CALL NO. 100
CONTRACT ID NO. 241306
ADDENDUM # 1

Subject: Breathitt County, NHPP 0151 (090)
Letting March 21, 2024

- (1) Added - Traffic Management Plan - Pages 583A-583L of 649
- (2) Revised - Plan Sheets U-039, U-041, U-042, U-044, U-045, U-047

Sheet No.	U-039
City of Jackson - Utility Relocation	BREATHITT COUNTY, KY - KY15, ITEM NO. 376.00
Date	2023-08-17
Drawn By	JCM
Scale	AS SHOWN
Job No.	933.40

CITY OF JACKSON
UTILITY RELOCATION
BREATHITT COUNTY, KY - KY15
ITEM NO. 10-376.00
COURT STREET LIFT STATION DETAILS

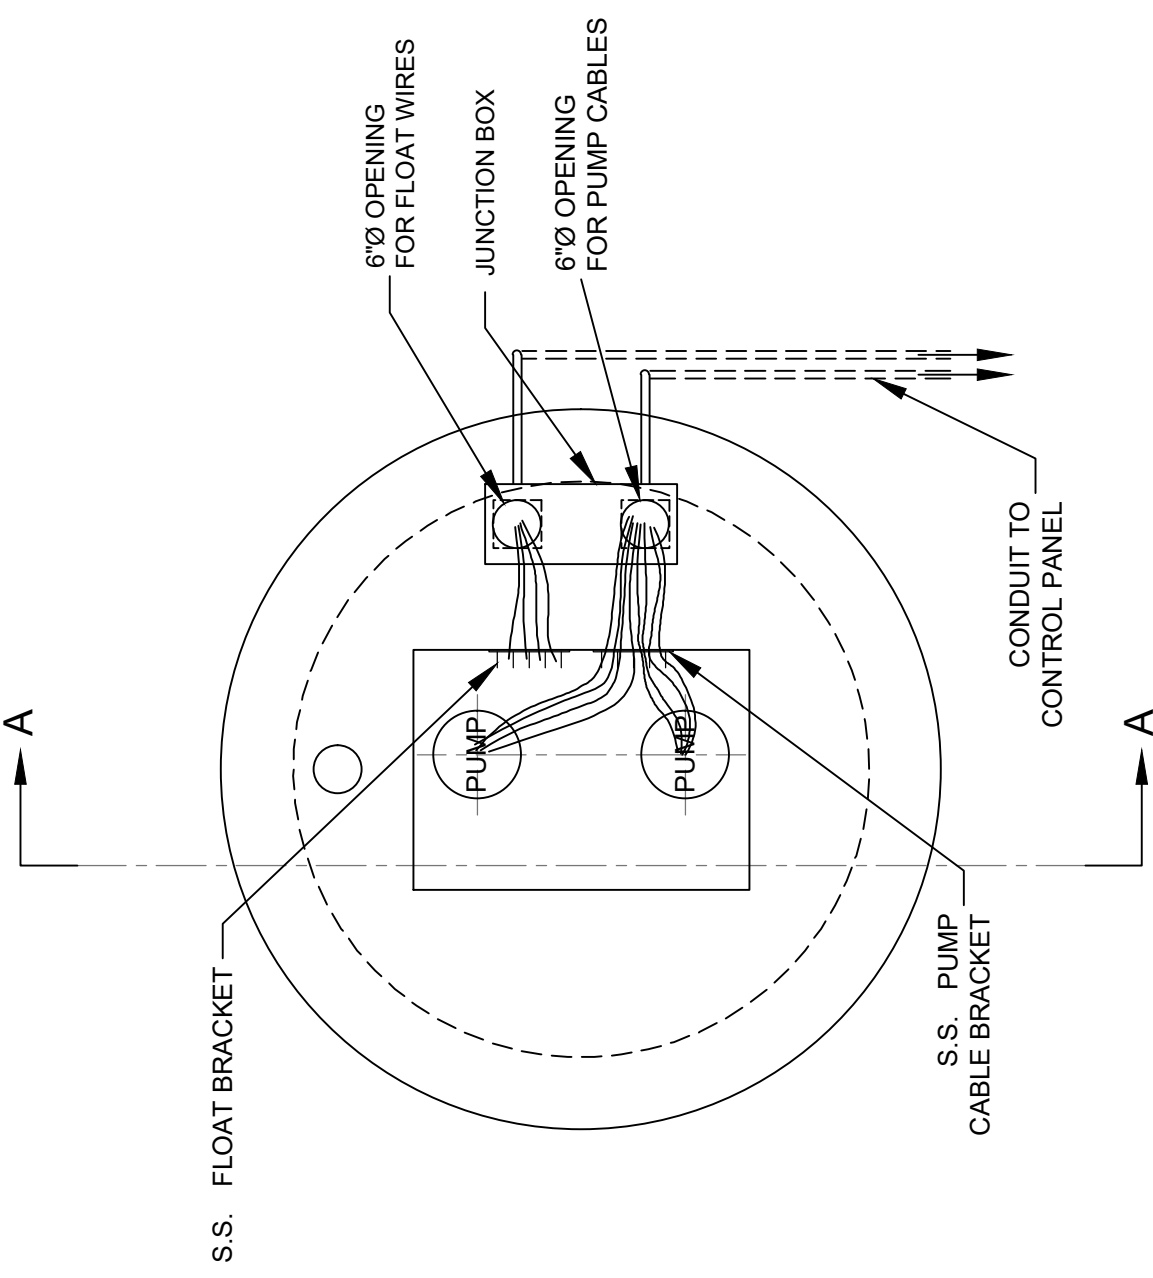
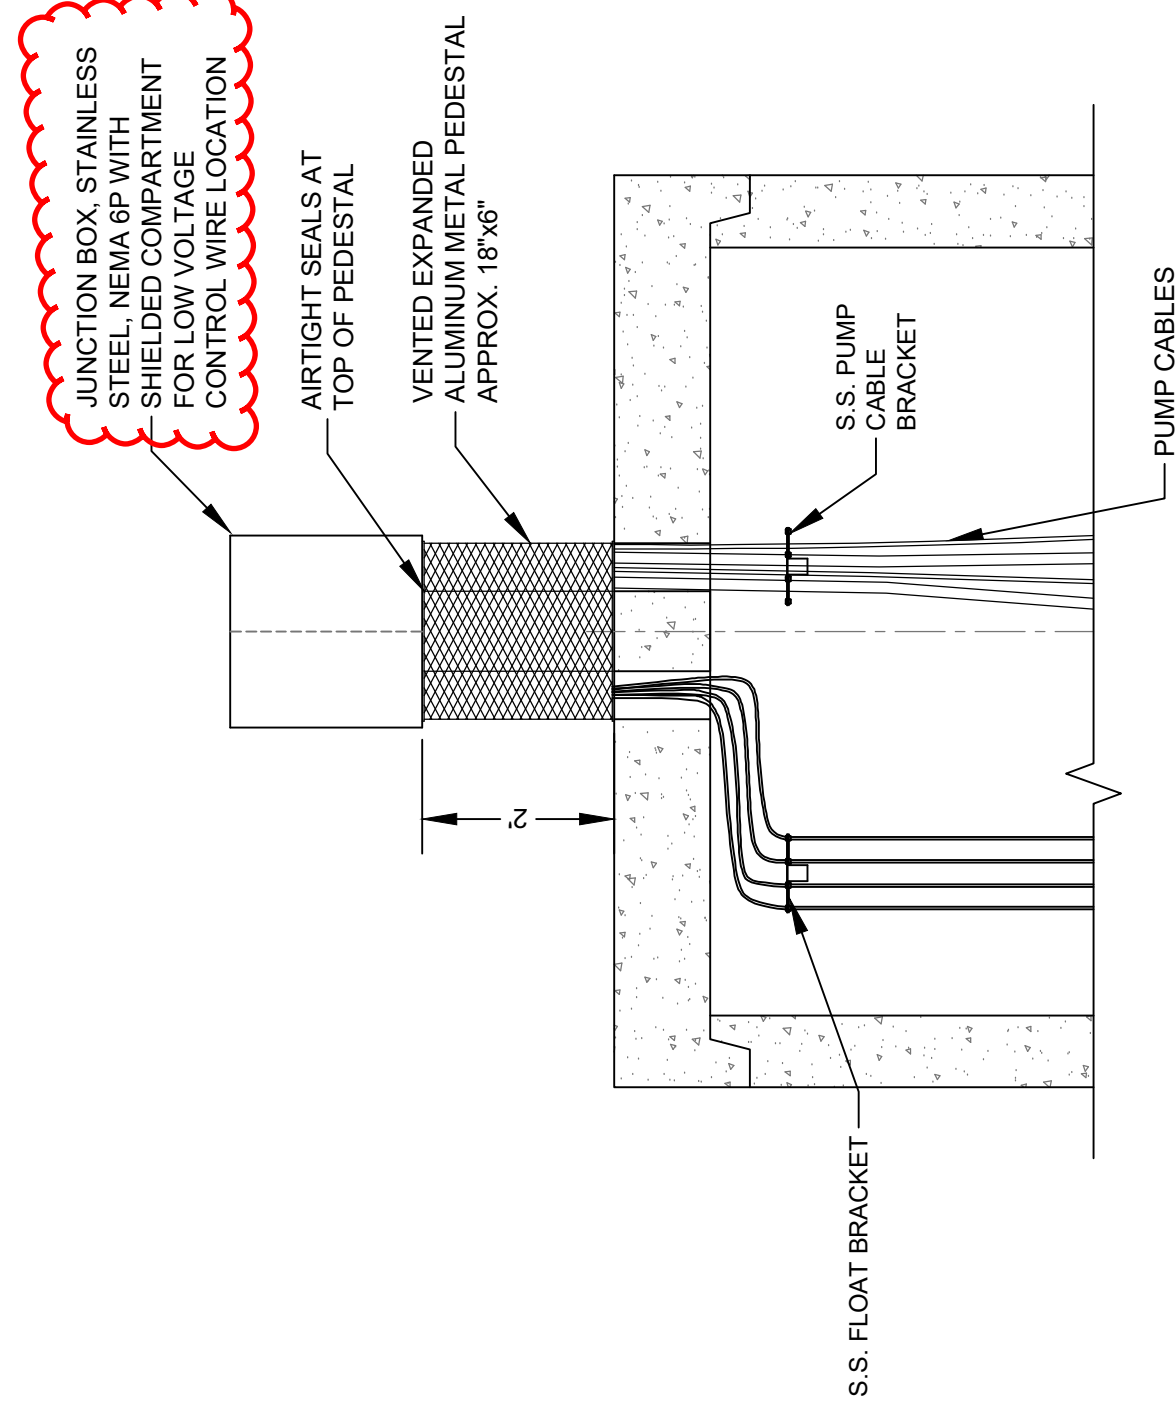
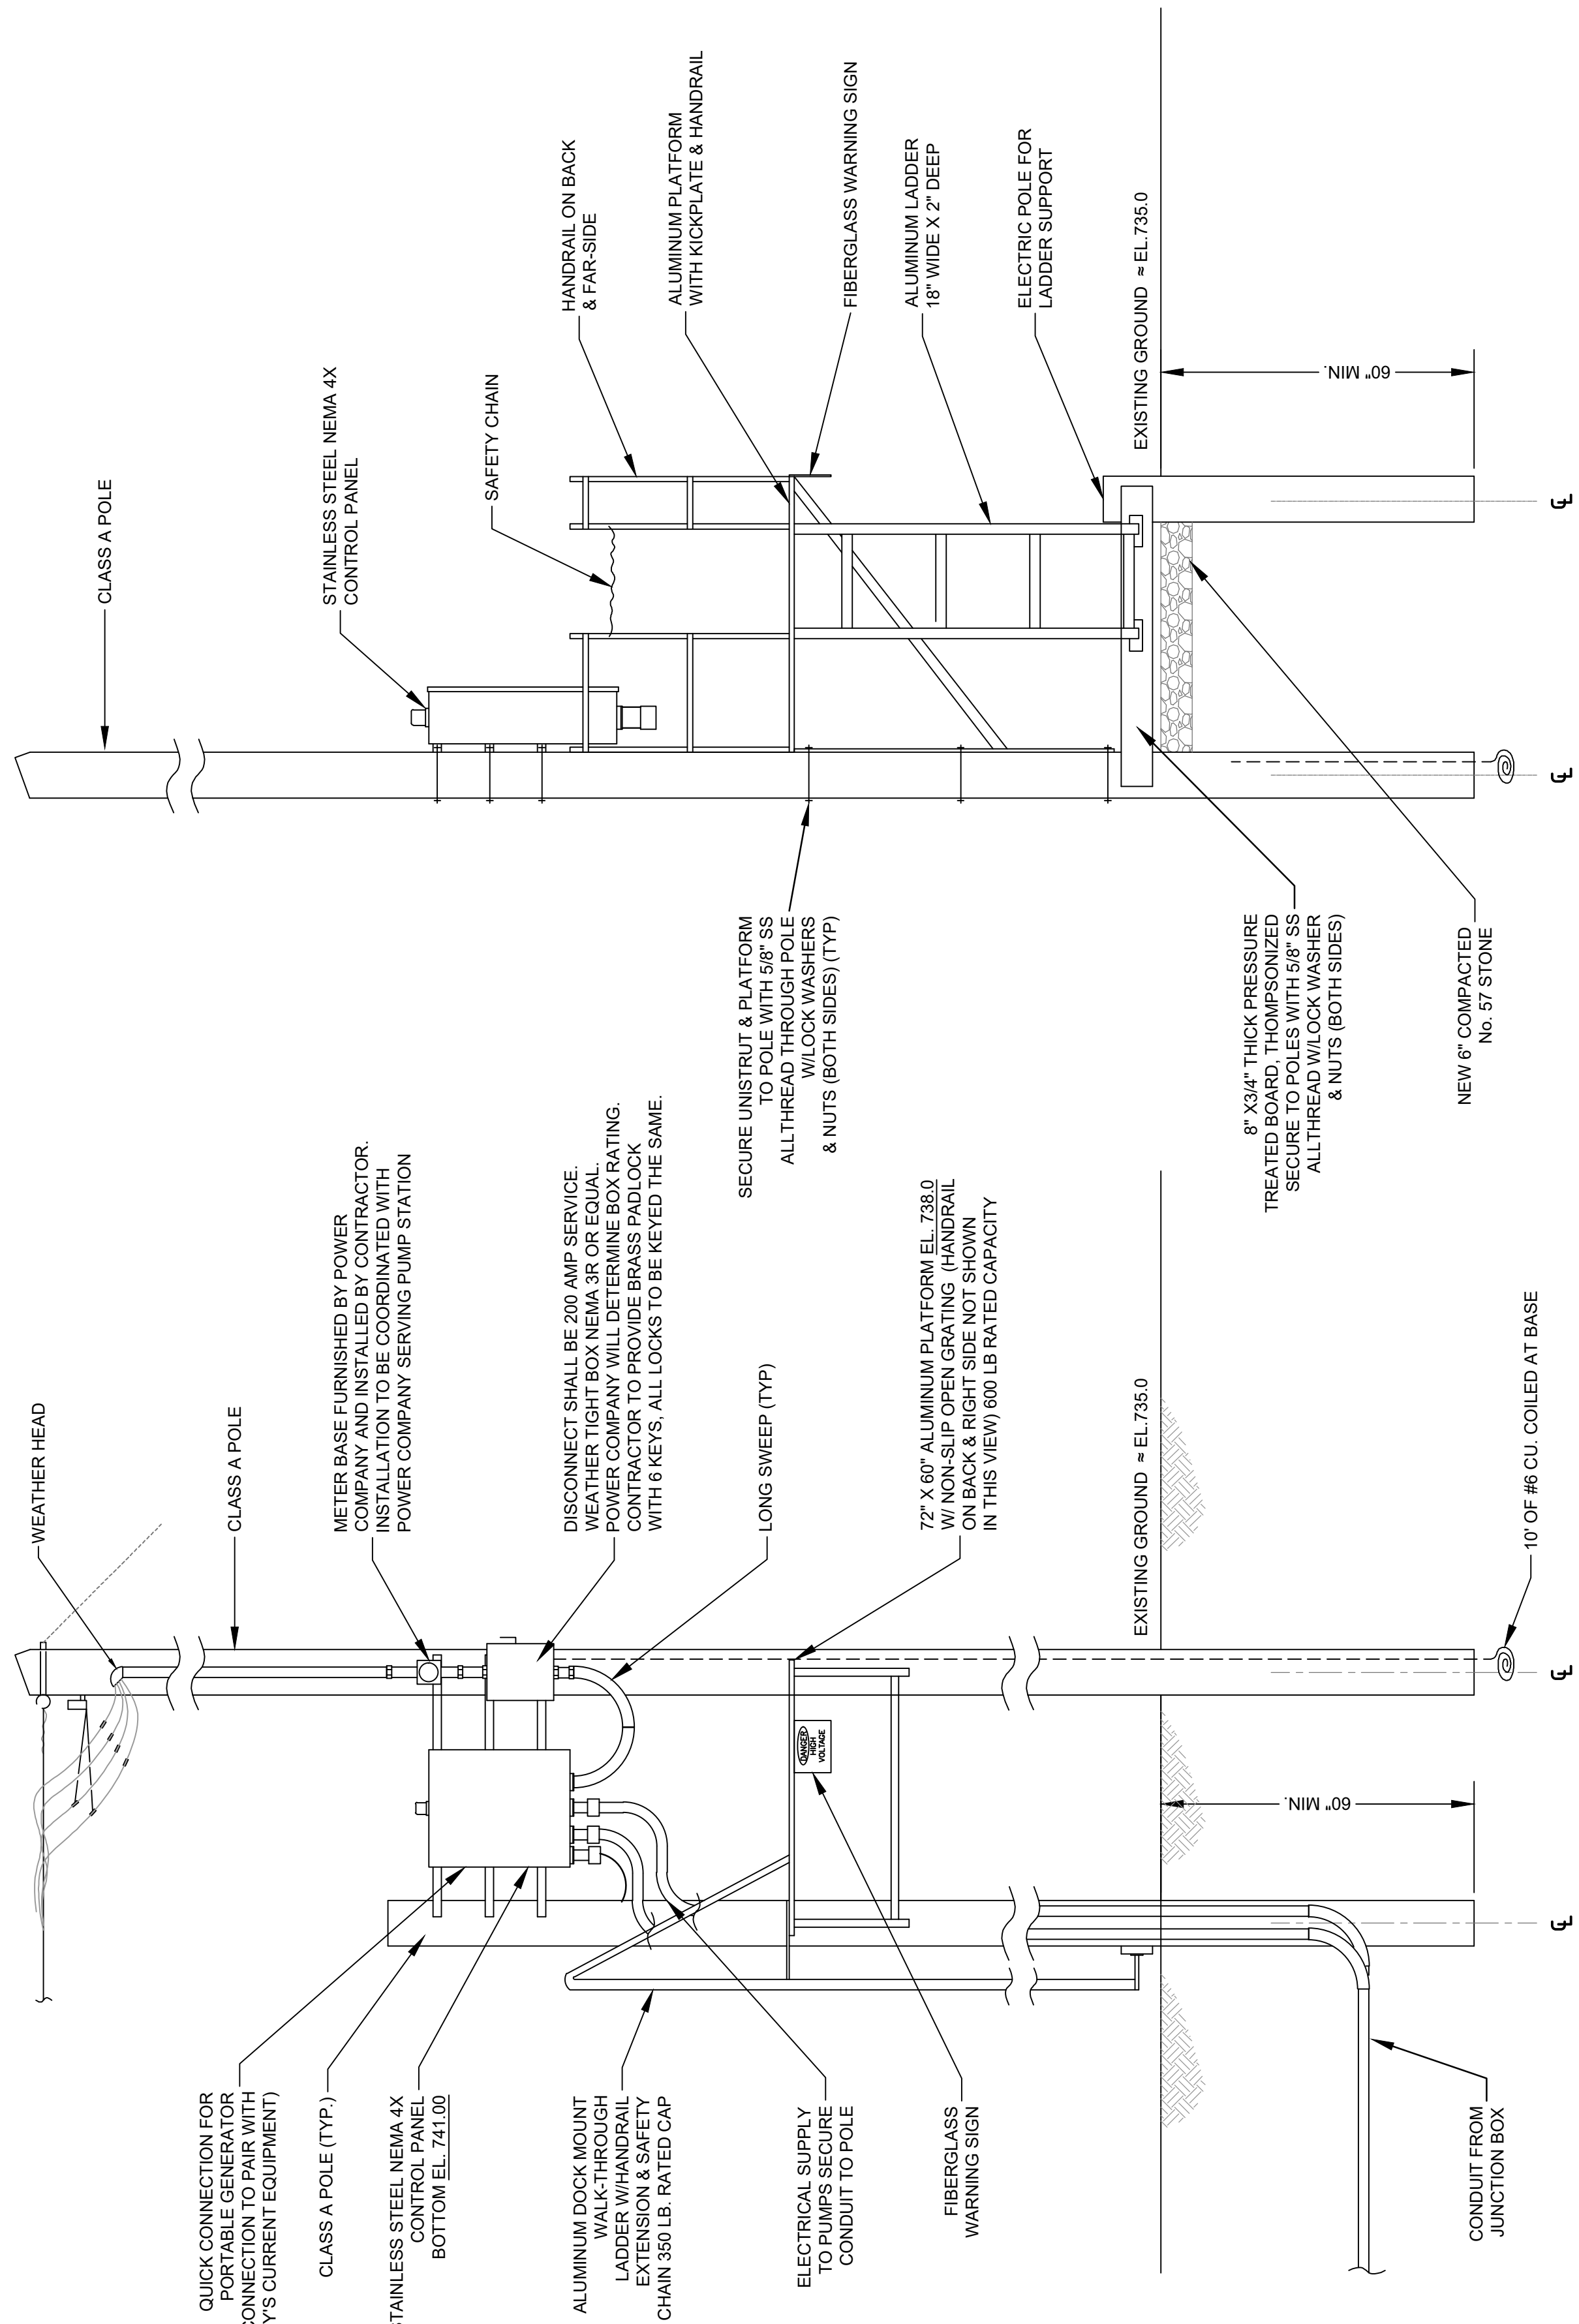
2024-02-20 ADD1 CHANGE JUNCTION BOX TO 6P
